#### **ADDENDUM NO. 1**

SUBJECT: Addendum No. 1 – Texas Avenue Sidewalk Project

**S002**

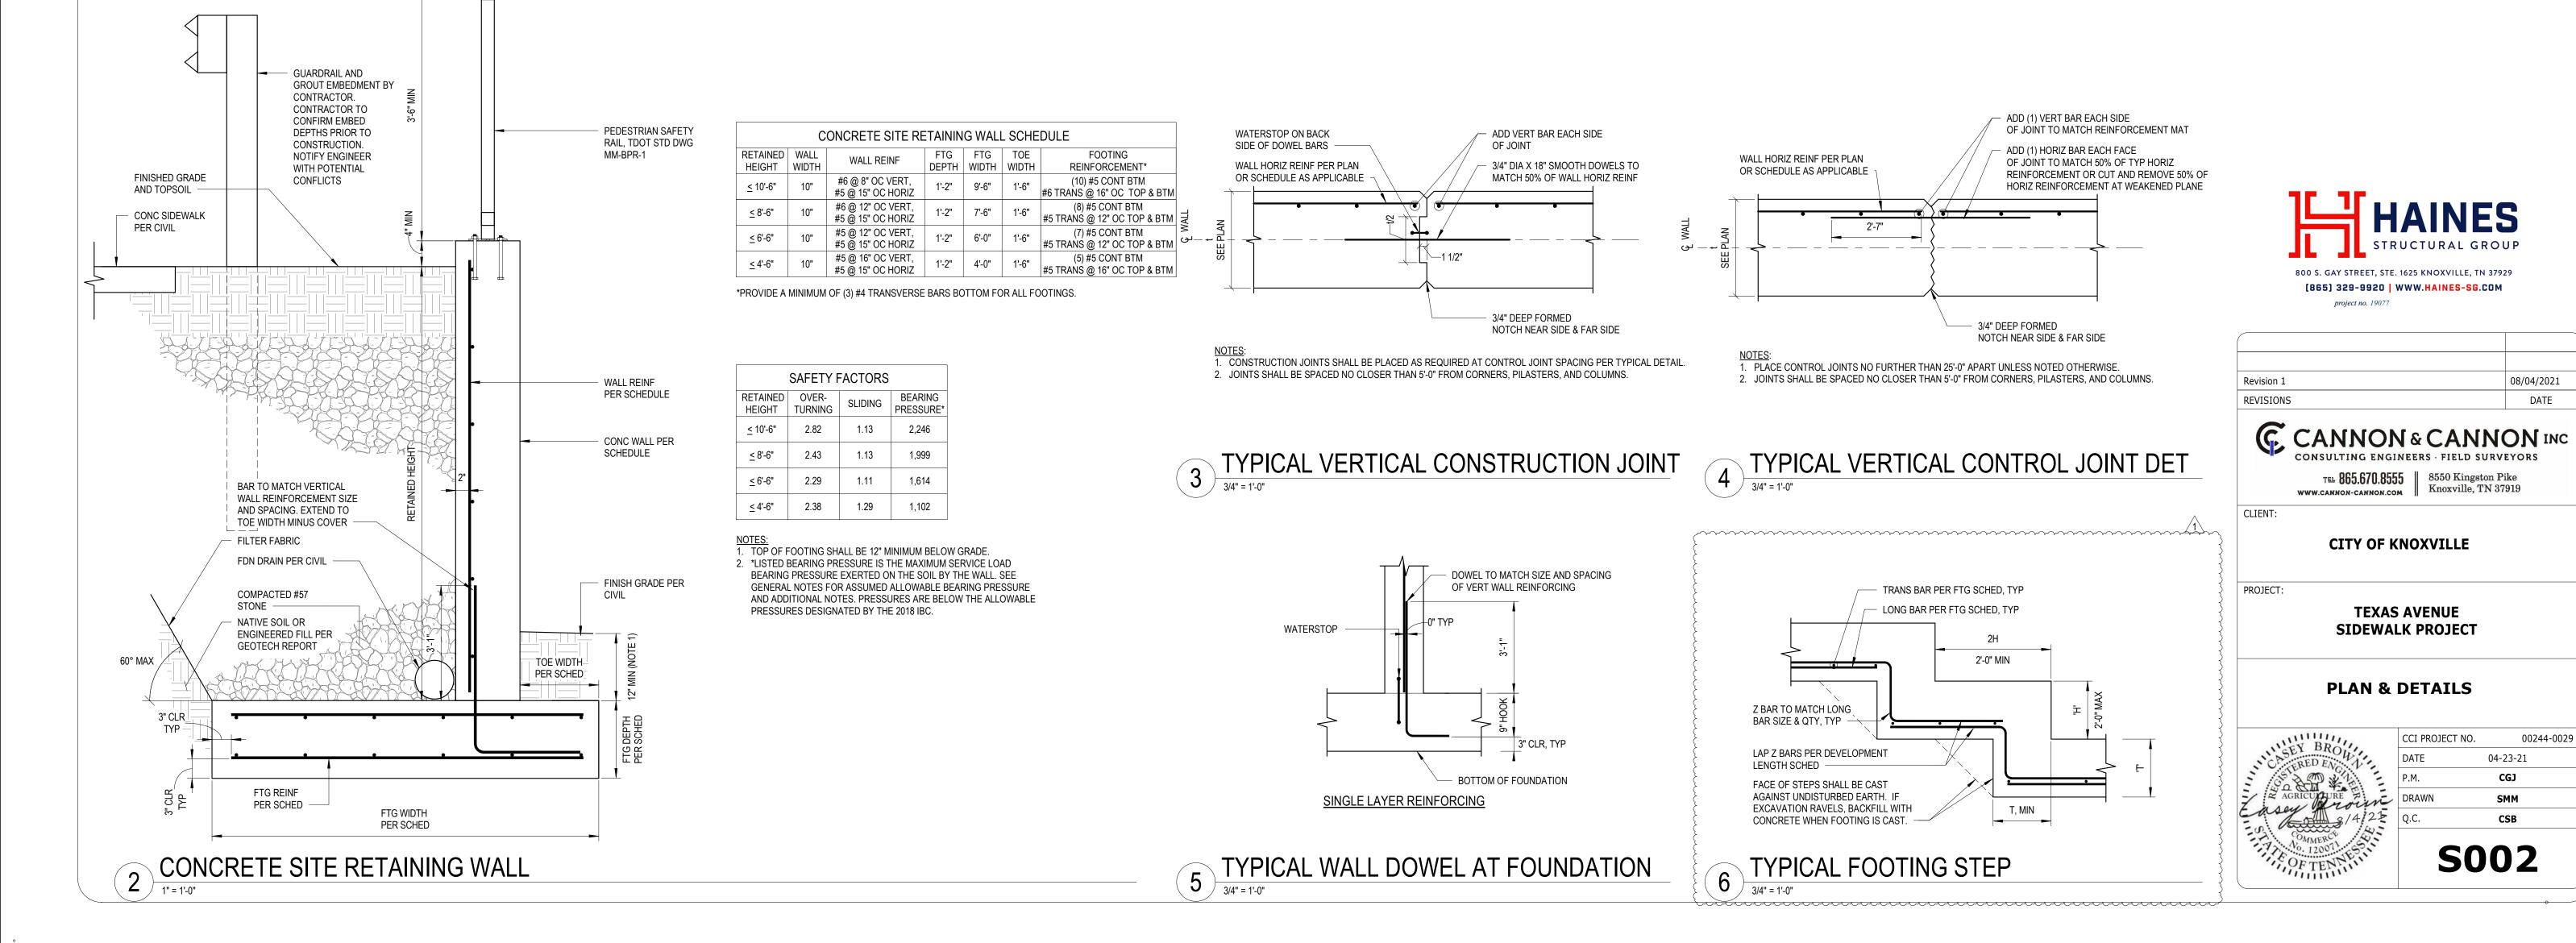
- 1. Q: Sheet 6B shows several steps in the retaining wall footer with elevation gaps between each step. Does this mean the footer is not continuous?
  - A: See revised plan sheet S002 that includes a new detail for a Typical Footing Step. The footing will be a continuous footing.
- 2. Q: See question 1, should there be a construction joint at every footer step?
  - A: No construction joints at the footer steps.
- 3. Q: How will the retaining wall be measured for payment?
  - A: Square foot of the face of wall, Wall height (top of footer to top of wall) x Wall Length. The retaining wall footing, steel and any other materials to construct the wall shall be included in the cost per square foot of wall face.
